Project	IEEE 802.16 Broadband Wireless Access Working Group < http://ieee802.org/16 >	
Title	Complementing Idle Mode Handover Operations	
Date Submitted	2004-06-07	
Source(s)	Beomjoon Kim, Kiseon Ryu, Yongho Kim, and Changjae Lee LG Electronics, Inc. 533,Hogye-1dong, Dongan-gu, Anyang-shi, Kyongki-do, 431-749 Korea	Voice: 82-31-450-7188 Fax: 82-31-450-7912 [mailto:beom@lge.com]
Re:		
Abstract	This document contains suggestions to complement idle mode handover operations	
Purpose	This document is submitted for review by 802.16e Working Group members	
Notice	This document has been prepared to assist IEEE 802.16. It is offered as a basis for discussion and is not binding on the contributing individual(s) or organization(s). The material in this document is subject to change in form and content after further study. The contributor(s) reserve(s) the right to add, amend or withdraw material contained herein.

Complementing Idle Mode Handover Operations

Beomjoon Kim, Kiseon Ryu, Yongho Kim, and Changjae Lee

Fig. 1. Procedures for network re-entry when an MSS moves outside the current paging zone

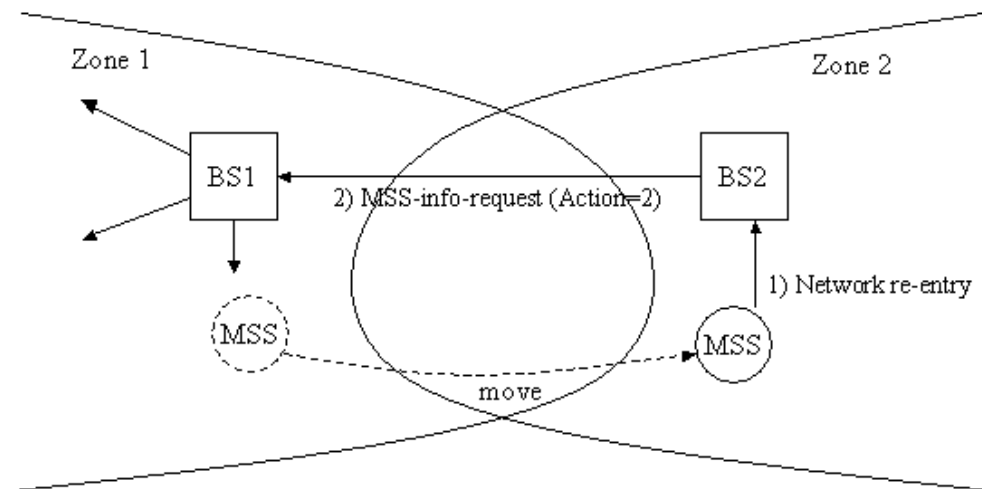
- (2) When an MSS tries to re-enter a network after passing over the coverage region of the initial paging group, the BS through which the MSS performs network re-entry cannot be informed of the initial BS that allows the MSS to enter Idle Mode. (See fig. 1.)

In this situation, the BS at which the MSS enters the network (BS2) cannot transmit MSS-info-request message to the BS that initiates the paging (BS1) because BS2 is not able to decide which zone the MSS comes from. It means that the BSs of the previous paging group, even if the MSS is not in their coverage region, should page the MSS’s MAC address every paging cycle in vain.

When an MSS moves outside the region of the paging group, the BS at which the MSS re-enter the network should be informed the identifier of the BS that initiated the paging in order to deliver MSS-info-request backbone message. Without it, the BS at which the MSS re-enter the network cannot decide where MSS-info-request message should be transmitted. For this purpose, TLV encoding of RNG_REQ may be modified as follows. (In last Session, there was a comment that Serving BS ID shall be used for this purpose, which was rejected because of Serving BS ID AGINGTIMER.)

The following parameter shall be included in the RNG-REQ message when the MSS is attempting to perform re-entry after terminating Idle Mode.

(Idle Mode) Initiating BS ID

The BS ID of the BS that allowed the MSS to enter Idle Mode. Inclusion of Initiating BS ID in the RNG-REQ message signals to the current BS where the MSS performs re-entry that MSS-info-request message shall be sent to the Initiating BS ID.
